Mr. Andrew McAllister  
Commissioner  
California Energy Commission  
Dockets Office, MS-4  
Re: Docket No. 14-AAER-1  
1516 Ninth Street  
Sacramento, CA 95814-5512

**Cree Comments on Draft Staff Report on Appliance  
Efficiency Pre-Rulemaking for Title 20 Standards --  
Analysis of Small Diameter Directional Lamp and Light  
Emitting Diode Lamp Efficiency Opportunities**

Following are Cree's comments and recommendations on the Draft Staff Report for 2014 Appliance Efficiency Pre-Rulemaking, Docket Number 14-AAER-1 – Analysis of Small Diameter Directional Lamp and Light Emitting Diode Lamp Efficiency Opportunities. We address the following items for LED Lamp Recommendations:

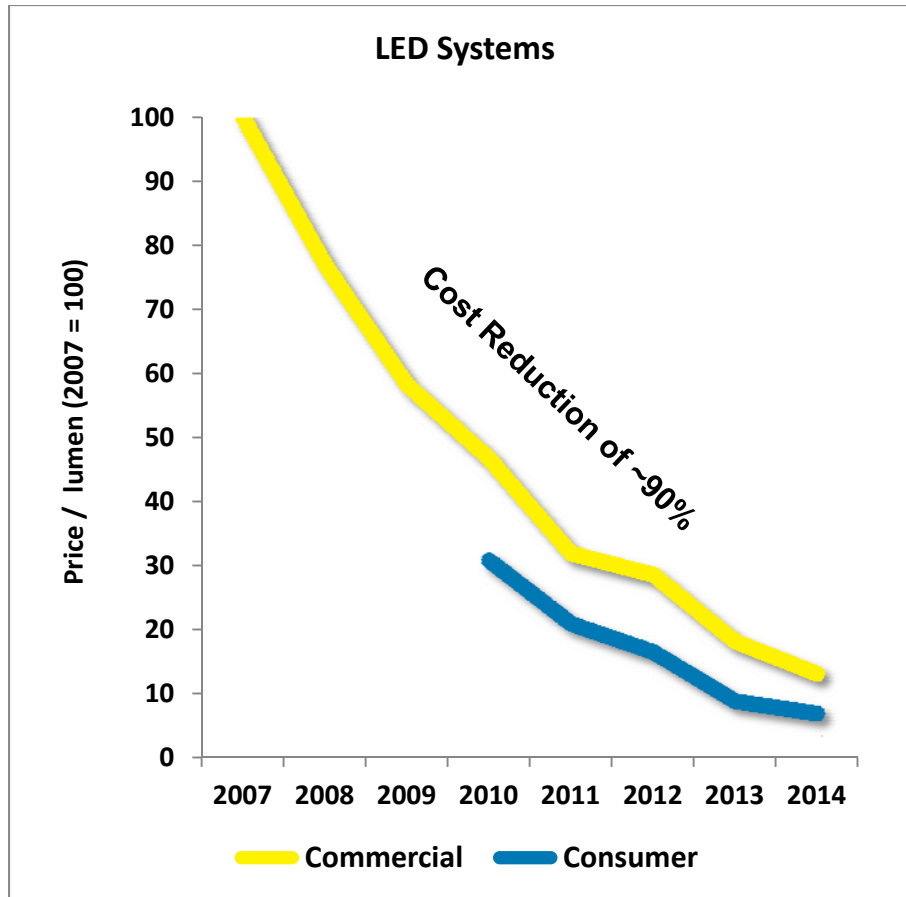
The current proposal to have a 2-step standard with minimum CRI and minimum Efficacy as outlined in Table K-13 introduces unnecessary complexity, and in being divergent from the proposed Title 24 standards outlined in JA8 will hinder manufacturers' ability to develop a common set of products to drive down costs and increase availability.

**Comments:** The primary objective of these standards is to drive energy savings in California. To maximize savings, we need to maximize adoption. Traditional lighting companies have repeatedly demonstrated that they are satisfied with limited adoption of energy-efficient lighting, as they continue to sell inefficient lighting to the rest of the market. Cree is solely focused on LED lighting, and our target is 100% adoption of energy-efficient LED lighting. 100% adoption requires lighting that's better, not compromised in important elements. Efficient lighting products that aren't installed and used deliver zero energy savings.

California should set the light quality bar high enough to facilitate adoption across the market. Committed manufacturers will innovate to deliver low-cost, high efficacy lamps with great light quality. Cree has delivered products to market using multiple technical approaches to achieve high-CRI, high-efficacy performance at competitive prices. Innovation is what is driving the LED lighting market adoption, and California should leverage coming improvements to achieve available energy savings.

Some parties have recommended against using CRI in energy efficiency standards. CRI is the accepted and well-understood metric available today, and at higher values, when used in conjunction with an R9 requirement, is an accurate measure of light color quality. While the industry works to develop, approve and gain acceptance for an improved measure, standards should continue to specify CRI with R9. If CRI minimum is set to 90, the requirement for each sample component of the CRI to be greater than 75 is fine with us.

**Cree's Recommendation** is to align the light quality requirements, as well as most of the other performance requirements, between Title 20, Title 24 and the Voluntary California Quality LED Lamp Specification. Require CRI minimum of 90, R9 minimum of 50 and Efficacy minimum of 55 lpw (higher than the current 45 lpw number). Manufacturers can design and build to a common set of requirements, consumers and businesses will enjoy a consistent experience, and California will facilitate greater energy-efficient lighting adoption.
